AR-07-1162

Southern Nuclear Operating Company
Vogtle Early Site Permit Application
Supplemental Response to Requests for Additional Information on Geology/Seismology

Supplemental Response to Geology/Seismology RAIs

Vogtle ESP Application

Figure 2g. Hard rock (solid red line) and top of Blue Bluff Marl (dashed blue and solid green line) seismic hazard curves for 0.5 Hz.

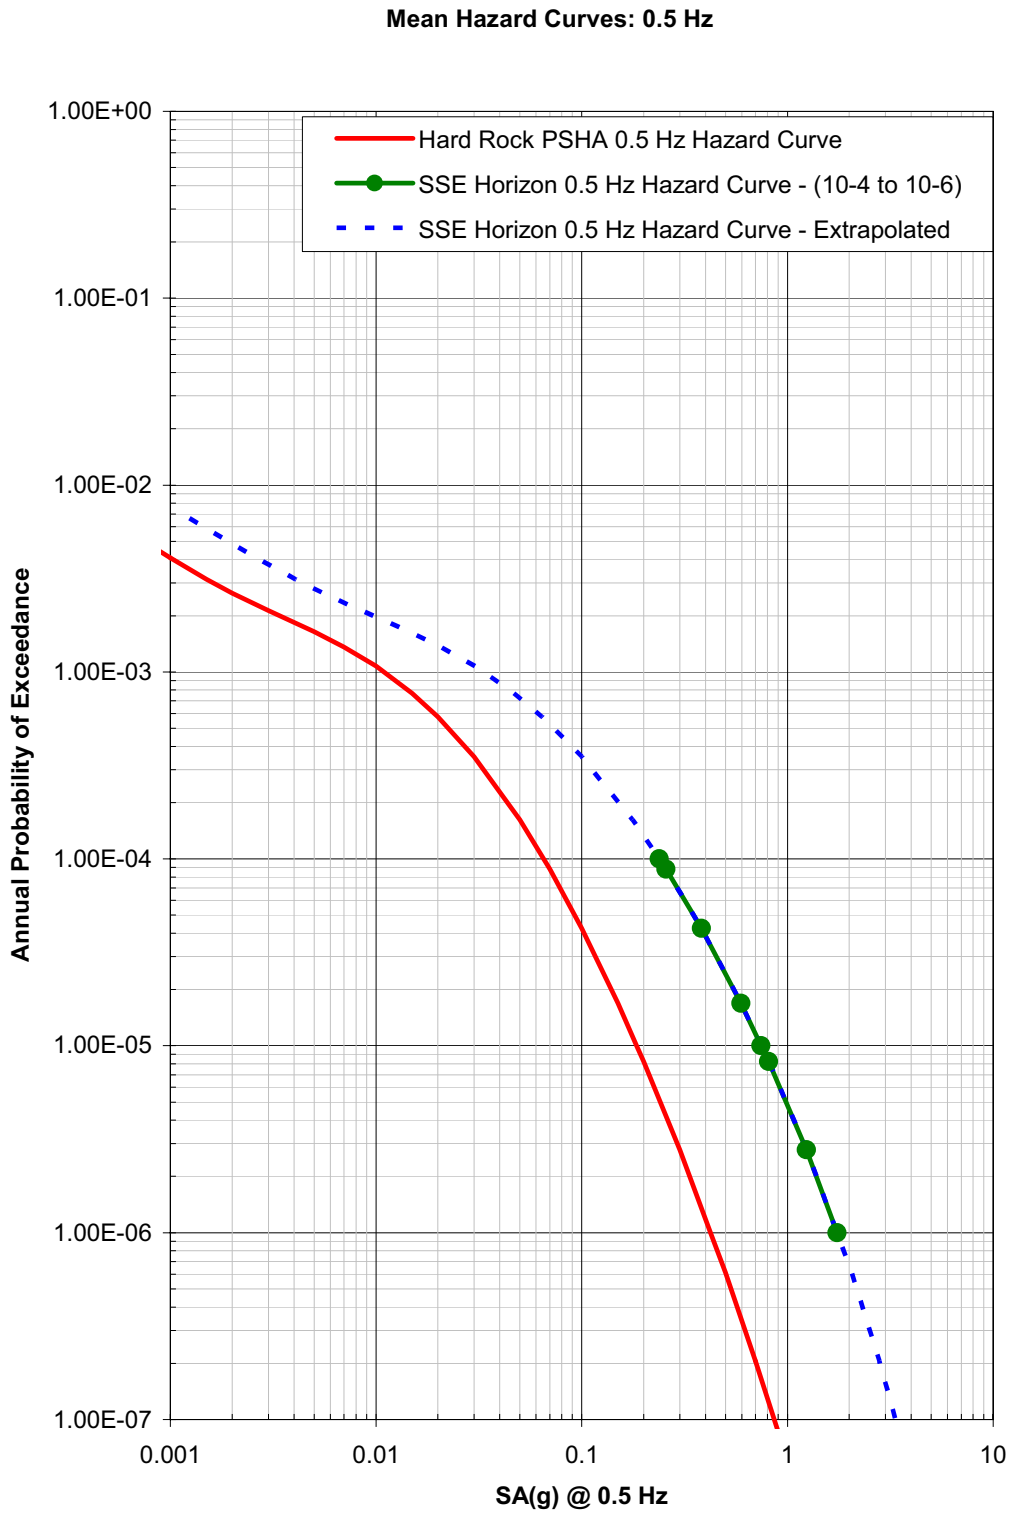
2.5.2-3 In response to this RAI, soil hazard curves were provided at three annual exceedence frequencies (10^{-4} , 10^{-5} , and 10^{-6}). However, in order for the staff to verify the adequacy of the SSE, soil hazard curves are requested at additional annual exceedence frequencies (i.e. at values between 10^{-4} , 10^{-5} , and 10^{-6}).

Next the hard rock hazard curves were scaled based on the functional amplification factor model for each frequency. The three hard rock ground motion values (see Table 1) corresponding to annual probability levels of 10^{-4} , 10^{-5} , and 10^{-6} were added to the suite of 25 points that defined the hard rock hazard curves (Risk Engineering Inc., 0521-ACR-032, 2006) prior to developing the top of Blue Bluff Marl hazard curves. For each of the seven frequencies, the top of Blue Bluff Marl seismic hazard curve was computed by scaling the hard rock ground motion values by the functional amplification model at each of the 28 annual probability level points that define the hard rock seismic hazard curves (see Table 2). A constraint was placed on the resulting top of Blue Bluff Marl hazard curves such that the resulting hazard curve does not decrease in ground motion for decreasing annual probability of exceedence levels. In cases where this constraint is applicable, the resulting top of Blue Bluff Marl hazard curve is vertical (i.e., the ground motion value is constant for decreasing annual probability levels).

The hard rock seismic hazard curves, amplification factors, and corresponding top of Blue Bluff Marl seismic hazard curves are listed in Table 2 for the seven frequencies. The three additional data points corresponding to probability levels of 10^{-4} , 10^{-5} , and 10^{-6} are indicated in bold. The hard rock (solid red line) and resulting top of Blue Bluff Marl seismic hazard curves are plotted in Figure 2. As indicated on each figure, the dashed blue line is based on the extrapolation of the amplification function beyond the range 10^{-4} to 10^{-6} and the green solid line with green circles is based on the interpolation of the amplification function over the range 10^{-4} to 10^{-6} .

Figure 2.5.2-18A: Seismicity in southeastern US and areas used to examine seismicity effects.

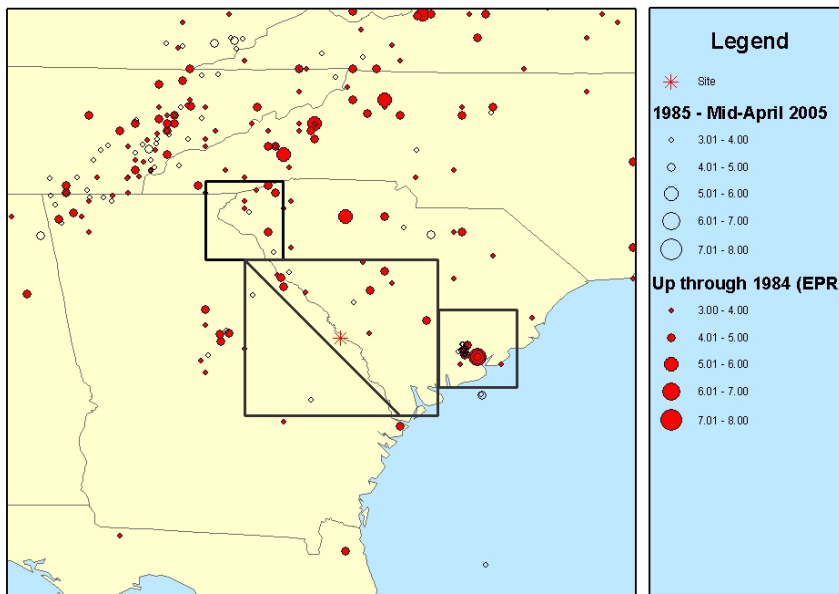
2.5.2-18 Please provide justification for the selection of the geometries shown in SSAR Figure 2.5.2-16 as well as RAI Figure 2.5.2-18A. Specifically, why were these particular geometries selected over other possible geometries? In addition, please justify the exclusion of the recent seismicity associated with the Helena Banks fault zone from all of the selected geometries.

Several areas were used to examine the effect of the new regional earthquake catalog. RAI figure 2.5.2-18A shows these areas. The areas were selected because sensitivity studies showed that seismic sources in the vicinity of the site, in the Charleston, South Carolina region, and in northwestern South Carolina were the main contributors to seismic hazard at the Vogtle site. The large rectangular source surrounding the site spans 2.5° longitude by 2° latitude, the source representing Charleston, South Carolina, spans 1° longitude by 1° latitude, and the source in northwestern South Carolina spans 1° longitude by 1° latitude. These sources were selected as representative of the regions important to seismic hazard analysis. In addition, the large source surrounding the site was divided with a diagonal line to capture seismicity in the northeast half of the source, so that seismicity would not be combined with the relatively aseismic, southwest half of the source.

SSAR Figure 2.5.2-37 Typical Results of Spectral Amplification at 86-ft Depth (Top of Blue Bluff Marl) Using EPRI Degradation Curves for High Frequency Time Histories of 10^{-4} MAFE Input Motion Level

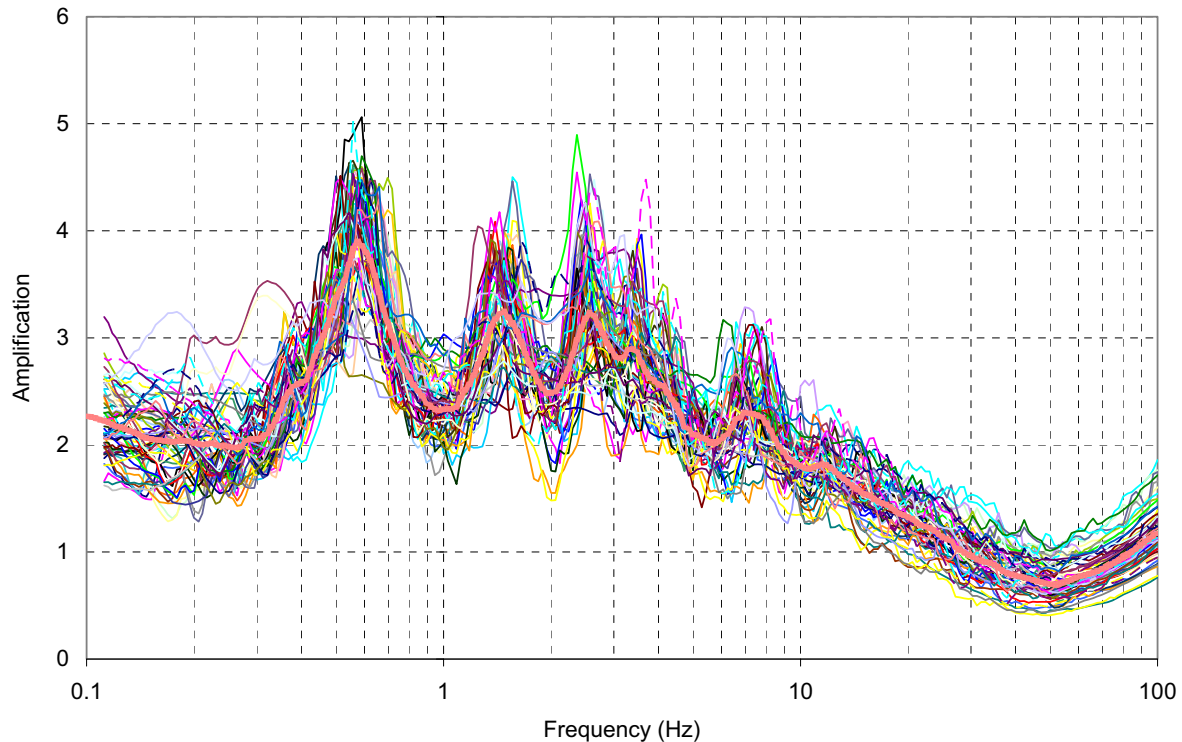
2.5.2-19 Supplement the RAI with additional information related to STEP 5. Please include a definition, and a figure (or table), of the envelope motion. The response to this RAI states

However, it is not clear if the envelope motion refers to the envelope of the mean AFs or envelope of the mean response spectra at the control point.

SSAR Figure 2.5.2-37, repeated below, illustrates the 60 individual AFs and the logarithmic mean AF across the frequency range of 0.1 Hz to 100 Hz, for the 10^{-4} MAFE, HF input, EPRI mean material curves, and 86' depth.
